Operational Alert: 158

Subject: Nose Gear Disconnect & Shimmy Damper

Models Effected: S-6 & S-16 Trike Configurations

## FIGURE 1

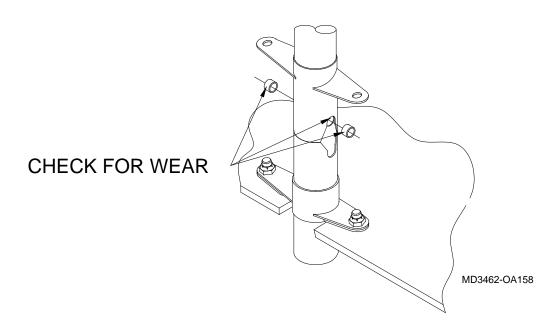
Nose Gear shimmy may occur if Nose Gear Disconnect components become worn. Inspect the 3/8" Steel Roller Bushing for grooving at every oil change. See FIGURE 1. Check for play between Steer Cam and Roller Bushing. Replace affected parts if play or wear is detected.
